Item ID: D212-664-101TRN Accept ***N900040100*** Setup Start ***NS1***
 Revision ID: Stop ***NS2***
 Item Name: Crosstube Turning Detail
 Start Date: 7/10/12 Start Qty: 1.00 ***1*** Cust Item ID:
 Required Date: 8/17/12 Req'd Qty: 1.00 ***1*** Customer:
 Reference:

DART AEROSPACE LTD	Work Order:	87556
Description: Crosstube Assembly (205/212/412 High Fwd)	Part Number:	D212-664-141
Inspection Dwg: D212-664-141 Rev: D		Page 1 of 2

DRAWING NO. D212-664-141	TITLE XTUBE ASSY (205/212/412 HI FWD)	REV. D	DART AEROSPACE LTD ENGINEERING ORDER		D.E.O. NO. D212-664-141-D-1	SHEET NO. SHEET 1 OF 2	SCALE NTS
DRAWN	CHECKED	MFG. APPR.	APPROVED	DE APPR.			
DATE 11.04.07	DATE 11.04.11	DATE 11.04.12	DATE 11/04/12	DATE 11.04.12

DRAWING NO. D212-664-141	TITLE CROSSTUBE ASS'Y (205 HI FWD)	REV. D	DART AEROSPACE LTD ENGINEERING ORDER	D.E.O. NO. D212-664-141-D-2	SHEET NO. SHEET 1 OF 1	SCALE NTS
DRAWN <i>UP</i>	CHECKED <i>ASS</i>	MFG. APPR. <i>AS</i>	APPROVED <i>MD</i>	DE APPR. <i>MD</i>		
DATE 11.07.15	DATE 11.07.20	DATE 11.07.21	DATE 11/07/21	DATE 11.07.21

**D212-664-141/-141B
ASSEMBLY DETAIL**

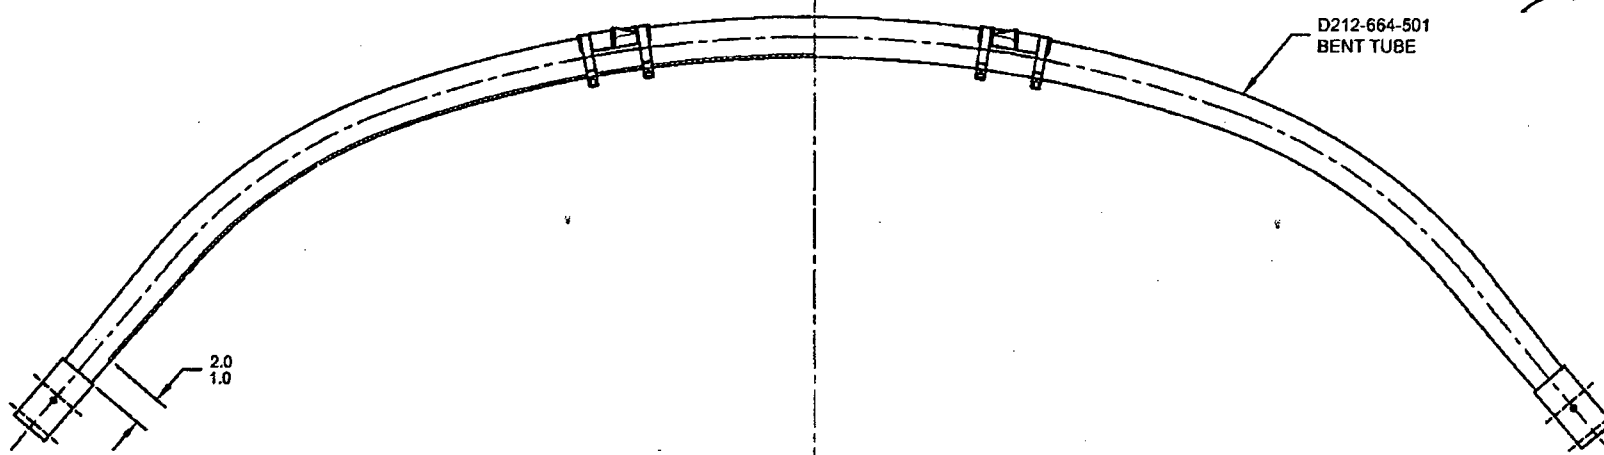
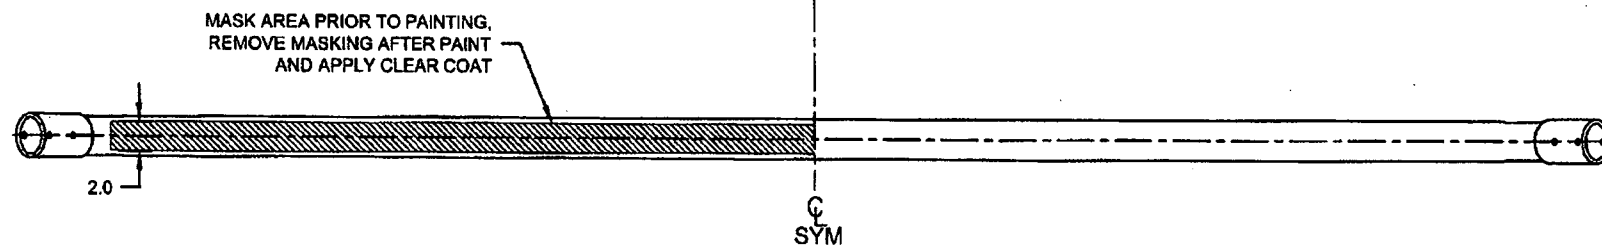
PURPOSE:

ADD AN INSPECTION WINDOW TO UNDERSIDE OF CROSSTUBE.

NOTES 2 OF SHEET 1 IS AMENDED AS FOLLOWS:

- 2) FINISH: CHEMICAL CONVERSION COAT PER DART QSI 005 4.1
PRIME INSIDE AND OUTSIDE PER DART QSI 005 4.2
MASK UNDERSIDE OF CROSSTUBE AS SHOWN (HATCHED AREA) AND
PAINT OUTSIDE PER DART QSI 005 4.2
REMOVE MASKING AND APPLY CLEAR COAT

- 2) FINISH: CHEMICAL CONVERSION COAT PER DART QSI 005 4.1
PRIME INSIDE AND OUTSIDE PER DART QSI 005 4.2
PAINT OUTSIDE PER DART QSI 005 4.2
